MFN 07-371

Docket No. 52-010

**Subject: Response to Portion of NRC Request for Additional Information Letter Nos. 01, 54 and 71 Related to ESBWR Design Certification Application – Radioactive Waste Management Systems - RAI Numbers 11.2-4S01, 11.2-11S01, 11.2.3-1S01, 11.3-3S01, 11.5-23S01 and 11.5-24S01**

**Markup of Supporting DCD Revision 3 Pages**

Figure 11.2-1. Liquid Waste Management System Process Diagram\*  
\*Similar to or Similar

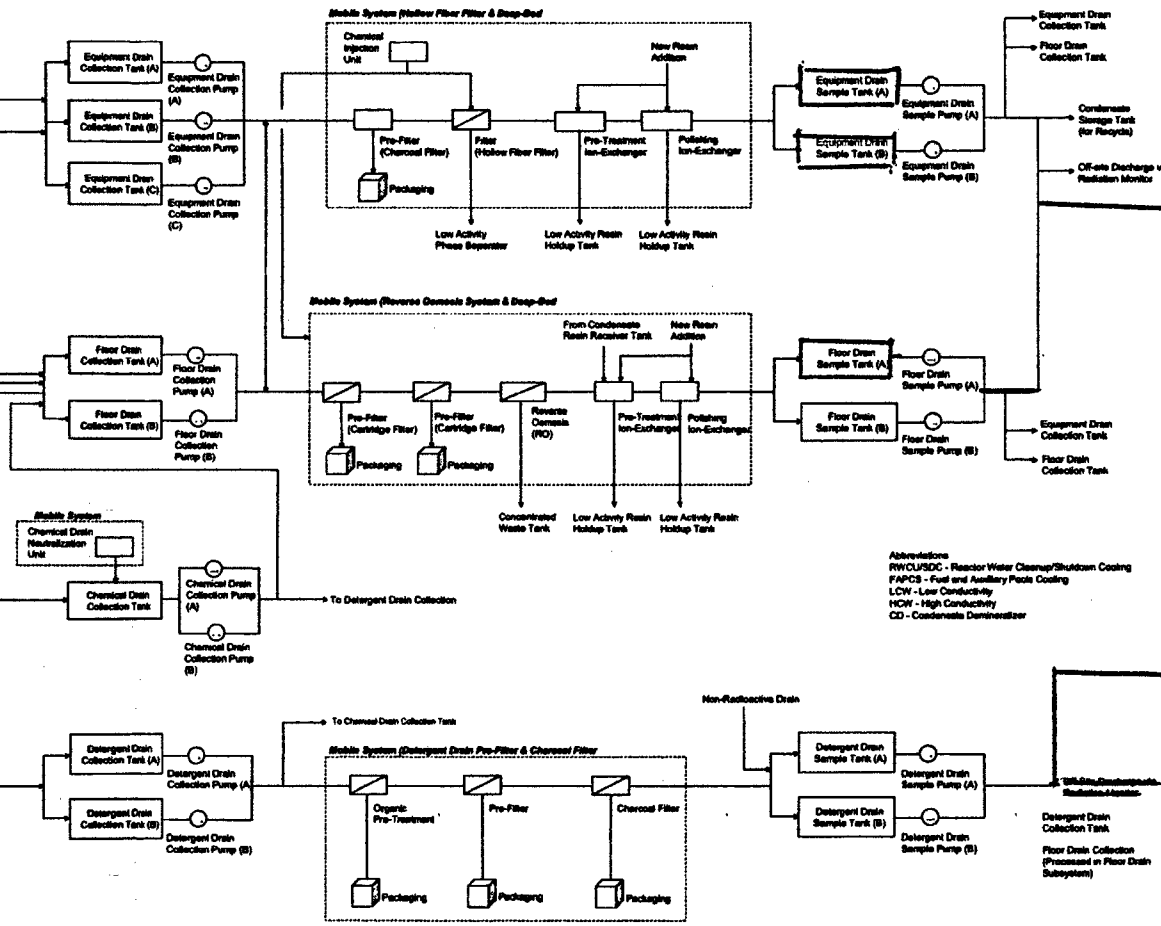
*In RAI 11.2-11, the staff requested additional detail to be provided for Figure 11.2-1, "Liquid Waste Management System Process Diagram." For example, the diagram did not show sufficient detail to identify all sources of liquid input volumes, the points of collection of liquid waste, the flow paths of liquids through the system including all bypasses, and the specific point of release of liquid effluents to the environment. The level of details should be sufficient to allow staff review in accordance with the guidance of SRP Section 11.2, Rev. 2, July 1981, Review Criterion III.1. In its response the applicant stated that the DCD Tier 2 would be revised to include a new Figure 11.2-2, "Liquid Waste Management System Process Stream Information Directory." Additionally, a description of Figure 11.2-2 was added in Section 11.2. The staff reviewed the revised figures in Revision 3 of the DCD Tier 2, and still could not find the specific point(s) of release of liquid effluents to the environment (e.g., interfacing with the circulating water system).*

The DCD will be revised to identify the specific release points to the environment.

DCD Tier 2, Subsections 11.2.3, 11.2.2.2, Figures 11.2-1 and 11.2-2 will be revised as noted on the attached markup in Enclosure 2.
